**STATE OF TENNESSEE
DEPARTMENT OF TRANSPORTATION**

INSTRUCTIONAL BULLETIN NO. 16-02

Regarding Revised Standard Drawings

Effective June 24, 2016 letting (April 13, 2016 Turn-in), the following Standard Drawings have been revised. Also, Section V of the Roadway Design Guidelines has been revised to incorporate these changes.

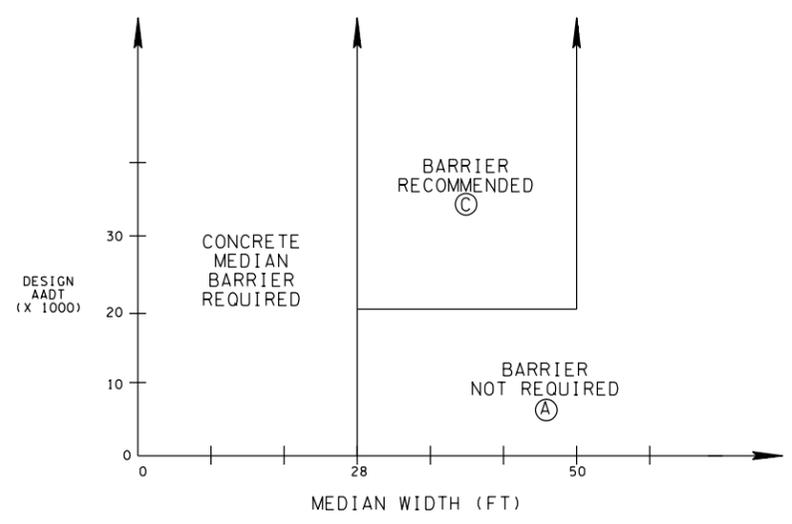
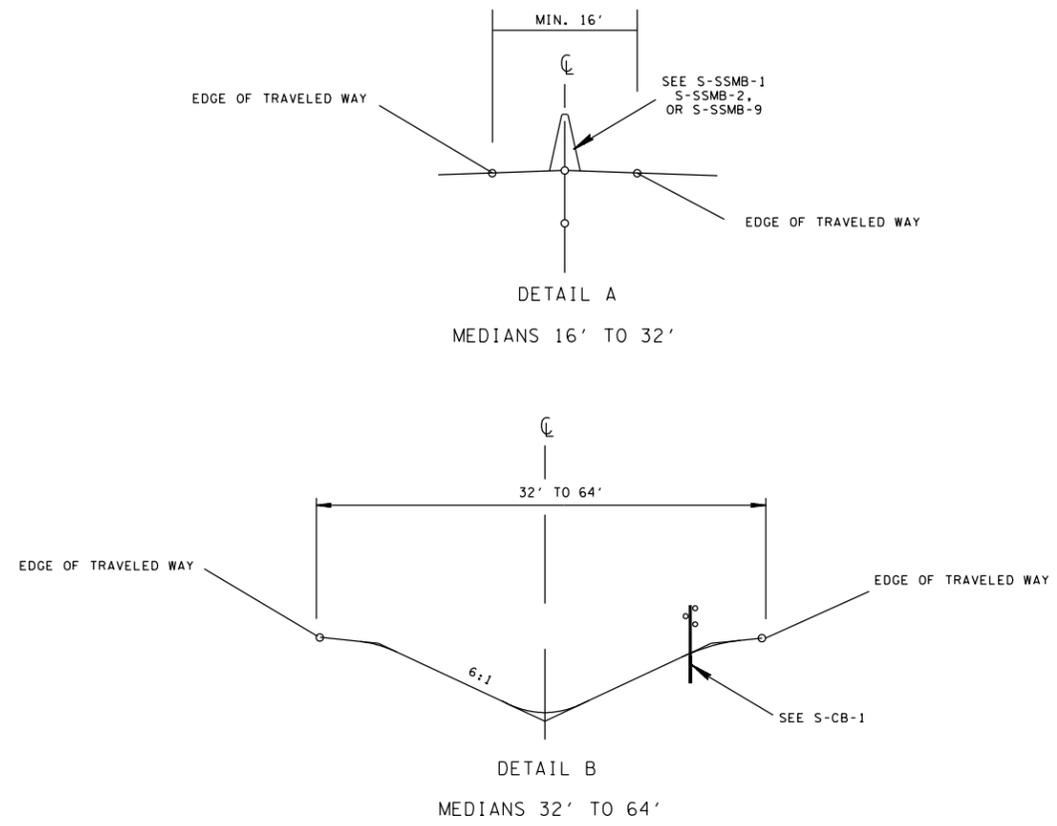
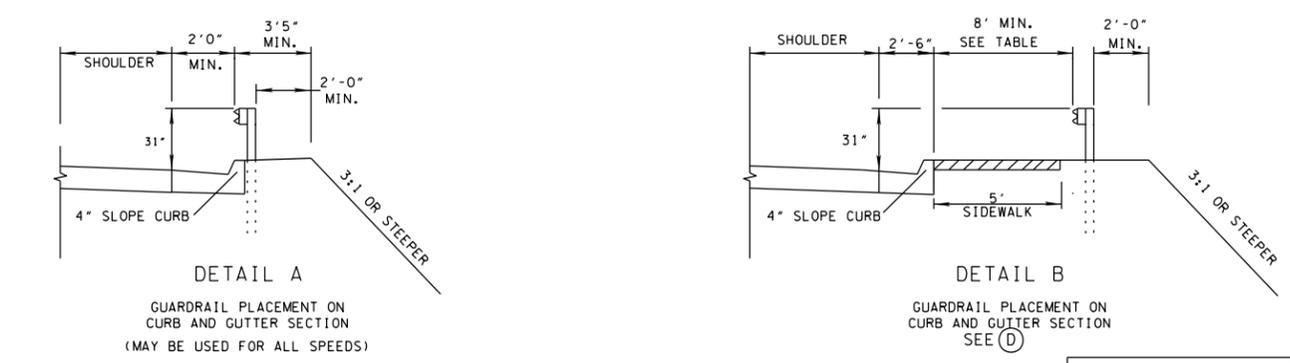
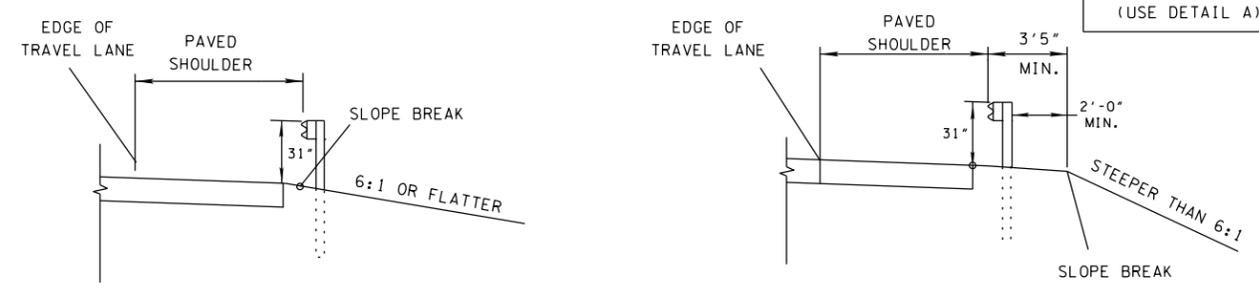
REV. 2-8-16: ADDED SLOPE TO POST LENGTH TABLE.

SLOPE	POST LENGTH
6:1	6'
4:1	7'
3:1	8'
2:1	9'
1:1	11'

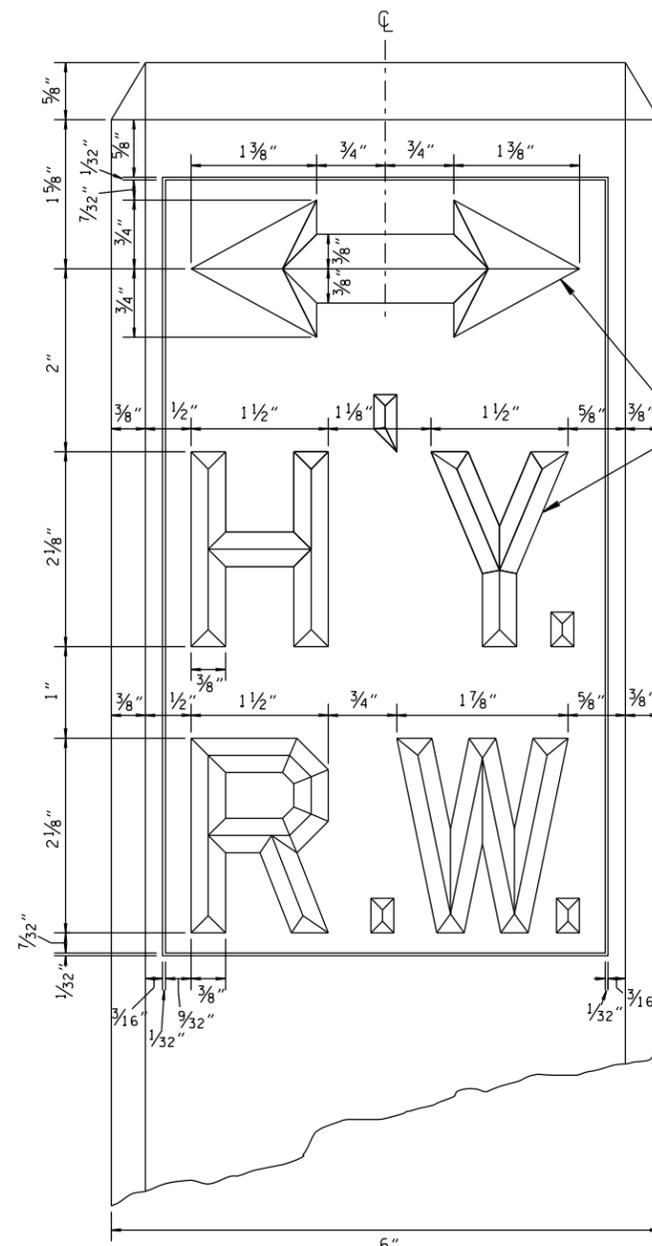
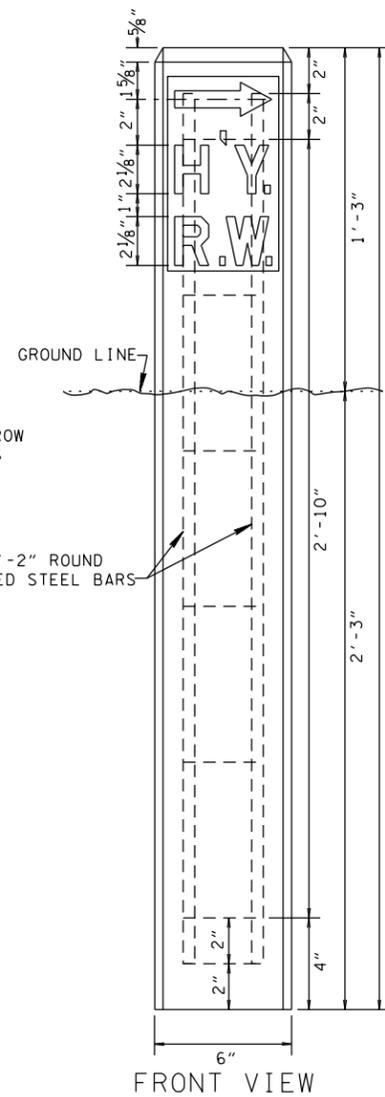
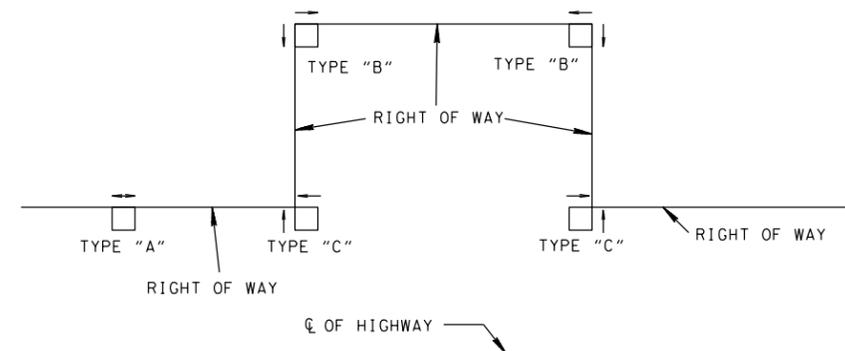
REV. 2-8-16: REVISED GENERAL NOTES.
